Technical Memorandum #1

Project Name: Graywood - Bronte Solid Waste Management

Client Name: Graywood Bronte Village Limited Partnership

**CONCEPTUAL
WASTE MANAGEMENT SYSTEM
GROUND FLOOR PLAN**

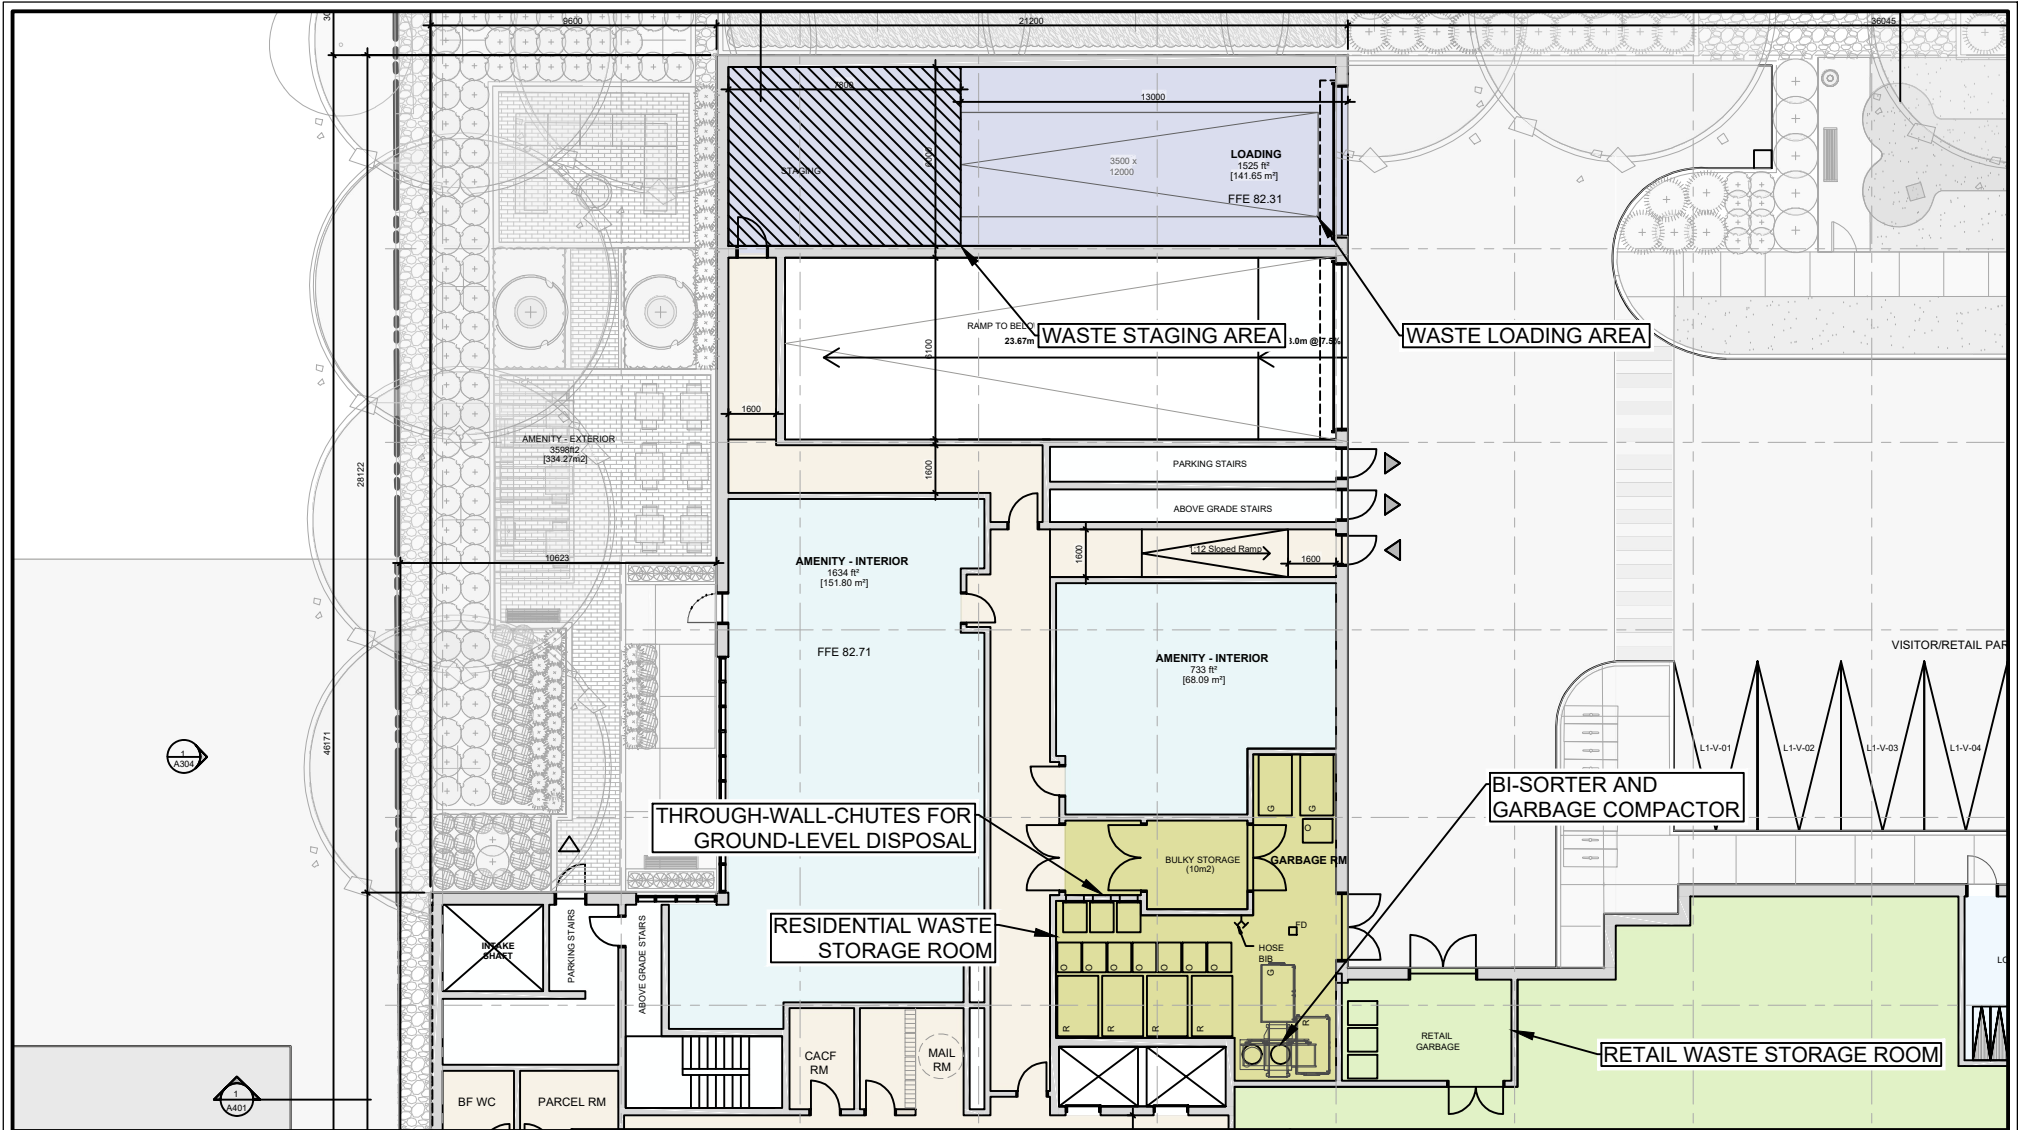
8. The Collection Point shall include the length of the truck (approximately 9.7 metres), plus the length of the staging area as determined by the number of waste receptacles required. As noted in item 11 (below), this will be a maximum of 9 metres.

9. The minimum required 'straight head-on' approach for the collection truck to the collection point is 18 m. If this 18 m head-on approach is not possible, the collection area must be designed such that the collection truck does not need to back up more than 18 m (from front tire to front tire). A turnaround area allowing for a three-point turn of not more than one truck length is an acceptable option to the Region.

10. Halton Region requires a 6.0 meter wide loading area.
 - a) The development intends to utilize a private service for residential waste collection. The 5.5 meter wide loading area will accommodate the development's needs.

As four bins are required for recycling, the staging area (assuming a 6 metre width) will entail a 2 by 3 bin-grid – meaning one bin in column 1 and three bins in column 2. The staging area required for this layout would be 6 metres wide by 9 metres long. This allows the driver to collect all bins without requiring bins to be jockeyed by a building maintenance staff. The length of the loading area should be increased to 9 m to meet this requirement.

- a) The staging area assumes private waste collection for residential waste. This can be accommodated within the provided staging and loading area.
